Access Compliance Report

Public Rights-of-Way

(Curb Ramps)

Intersection ID: 3346	Main Street: BARRISTER_WY	Cross Street: STEINBECK_CT	Location:	N
ADA ID: F5863A9186FB	Ramp Type: BlendTrans2	Initial Pass/Fail: Fail	Overall Compliance: No	Severity Score: 1.25
Codes/Mitigation Info/Possible Solution		Field Measurements/Component Compliance

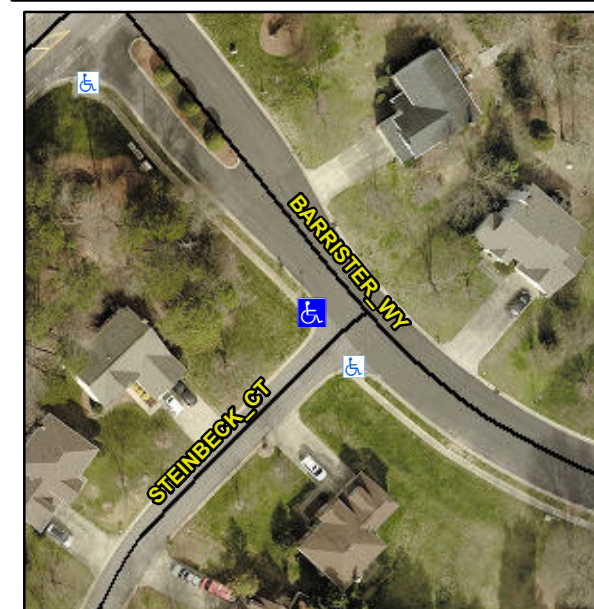
Remove & Replace Curb Ramp With Two New Directional Ramps or Equivalent.

Not Found, R304.5.3
